CABINET MEMBER FOR ENVIRONMENT – 25 FEBRUARY 2021

ISLIP – B4027 RIVER BRIDGE AND WHEATLEY ROAD: PROPOSED TRAFFIC SIGNALS INCLUDING ONE -WAY RESTRICTION ON MILL STREET AND SPEED LIMIT CHANGES

Report by Interim Corporate Director Communities

Drawing title 20/40mph extension					
Drawing Status					
Scale @ A3	Drawn by GG	Checked by DC	Approved by		
	Date drawn 09/11/20	Date checked	Date approved		
Oxfordshire Project No. & File Ref

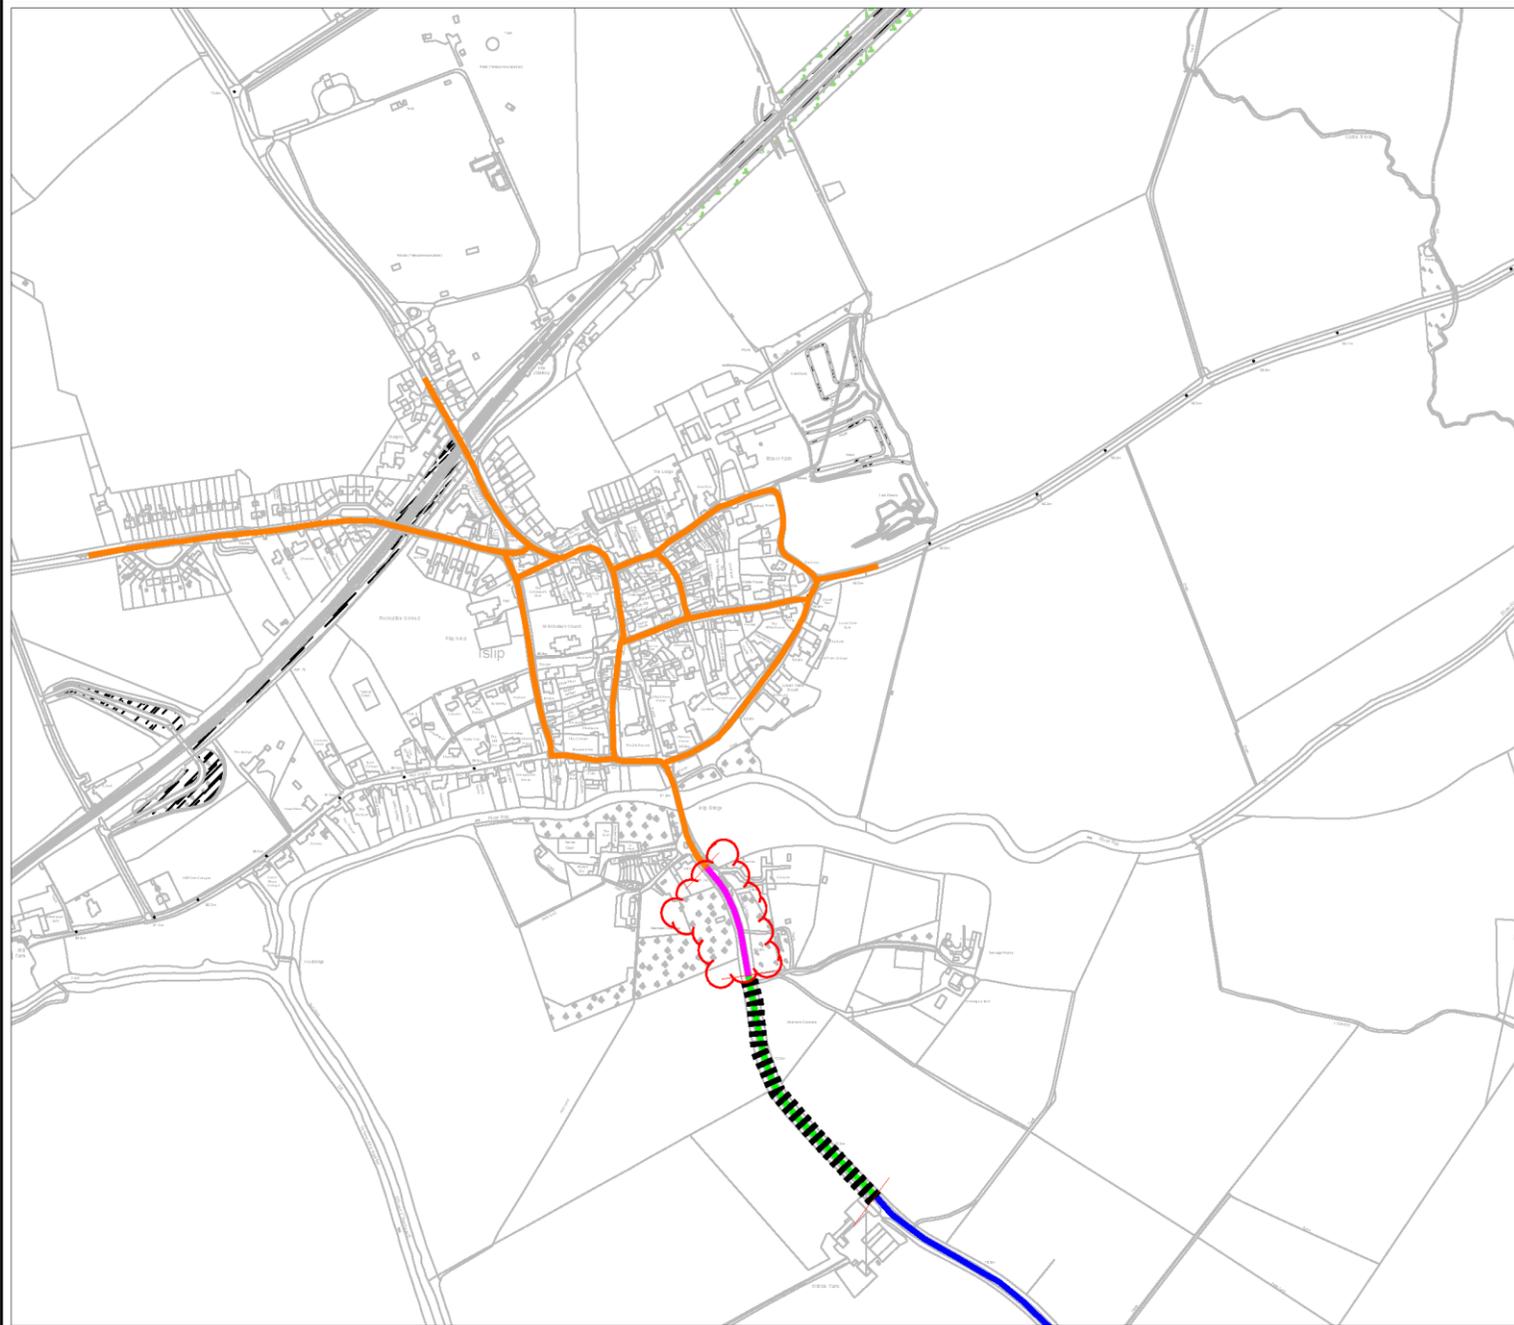
18. Thames Valley Police objected to the extension of the 20mph speed limit on the grounds that without further supporting measures compliance will be low. Cherwell District Council did not object and 25 expressions of support were received from members of the public (including a petition with 23 signatures).
19. The extension to the 20mph is at the request of Islip Parish Council who are part funding, due to reduced visibility. While acknowledging the concerns of Thames Valley Police, in this instance with the introduction of the traffic signals there is also an increased risk of rear end shunts. The extension of the 20mph and 40mph buffer can be seen as complementary to this where signing will reflect this and the new signalized bridge
20. However, the scope for further engineering measures that can be introduced to alleviate the concerns of TVP will be investigated.

RESPONDENT	COMMENTS
(1) Traffic Management Officer, (Thames Valley Police)	<p>Object – Thames Valley Police are not opposed to lowering speed limits providing they are appropriate to the road environment and likely to have casualty reduction benefits. All aspects of the proposed speed limit are taken into account i.e. collision history, speed of existing traffic, road environment, enforcement, road character function with driver perception.</p> <p>No speed data has been sent despite requests where the current speed of traffic is a reliable indicator of how acceptable a new speed limit would be. The recognized way of ascertaining this level of self-compliance is the 85th percentile speed. If the 85th percentile speed is 7mph or more over the proposed limit it is unlikely to be effective without other measures such as engineering or continual enforcement. I am also aware Highway Authorities prefer to use Mean speed rather than 85th percentile.</p> <p>The Islip village 20mph speed limit was appropriate given the speed data and existing calming with road character where at that time the Wheatley road was singled out for consideration but left out of the Order appropriately. At that time existing speeds were within Police/Dft guidelines being compliant without further calming and no expectation for Police supervision. The approach on Wheatley road is rural unlit and has a blind bend where queuing traffic and rear shunts have been cited as strong potential with the signalisation of the bridge being considered. Extending the 20mph without additional engineering or other safety mitigation measures may render the location less safe given the nature of the road?!</p> <p>There is a proven link between road environment/character and drivers speed. Drivers' must respect the need for a speed limit . If not accepted as realistic from our experience a limit will quickly be abused and be the source of constant demands for police action. Communities not privy to this response will thereafter and be unhappy and dissatisfied with the residual situation which Police activity would never satisfy.</p> <p>The policy of Thames Valley Police is to use sound practical and realistic criteria (Circular Roads 1/2013) when responding to Highway Authorities in an effort to promote consistency and to reduce the burden of constant and unnecessary enforcement. The advice shown in Circular Roads 1/2013 states Speed Limits should not be used to attempt to solve the problem of isolated hazards which is the case here (Bridge signalisation), junctions or reduced</p>

<p>forward visibility.</p> <p>Thames Valley Police object to the extended 20mph speed limit and seek a safe engineering solution to the bridge signalisation scheme and potential for traffic queuing on road safety casualty reduction grounds.</p>

Proposed Cross Section "A-A" of Carriageway & Footway

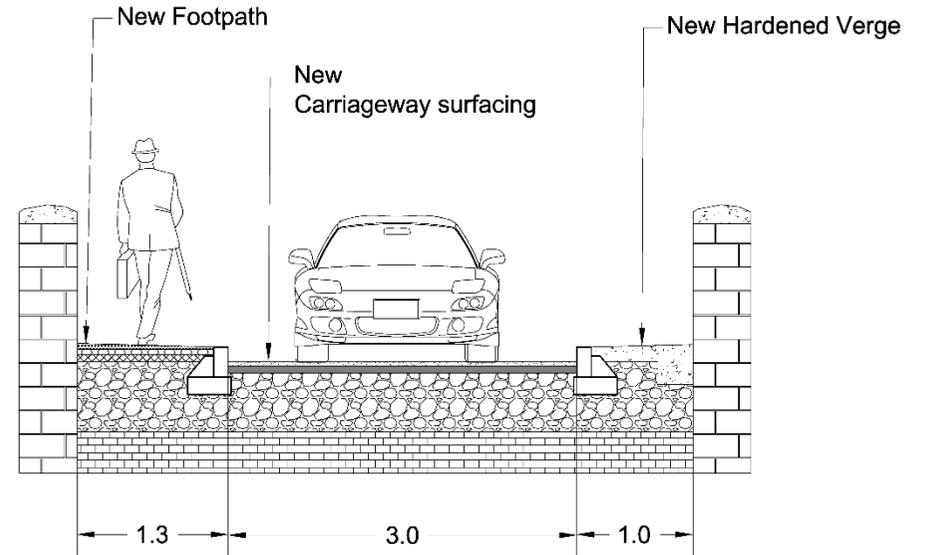
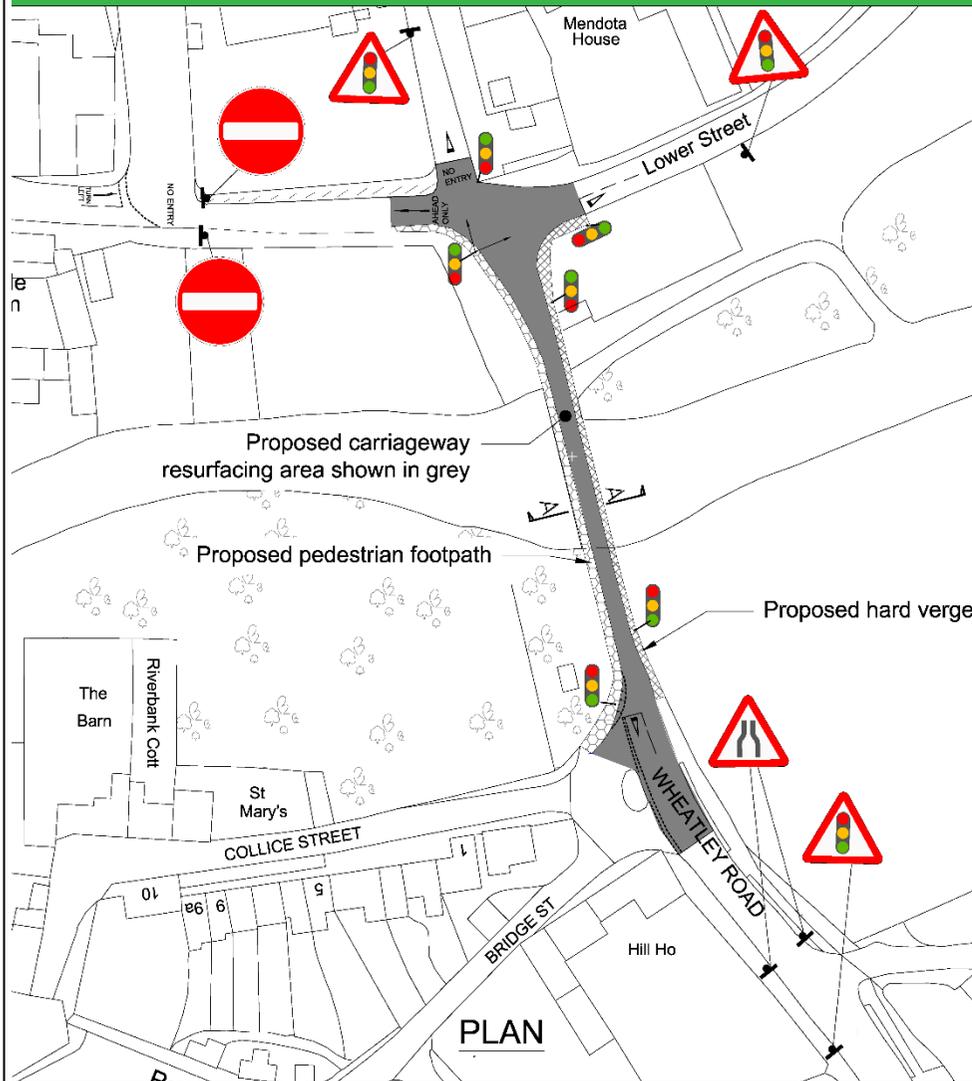
- (30) Similar to (5), with more specific concerns of the proposed raised verges damaging the agricultural vehicles tyres.

A balance between all the objectives is being made, with the raised verges only being 50mm high for improving the drainage and keeping the single lane of traffic controlled by traffic signals away from the edge of the bridge. The kerbing is also to deter vehicles mounting the area designated for pedestrians. The proposed measures are not anticipated to cause damage to large agricultural vehicle tyres that over run the raised verges. These large tyres are anticipated to be able to suitably spread their load that they do not damage the edges of the bridge. This will be further reviewed at the detailed design stage.
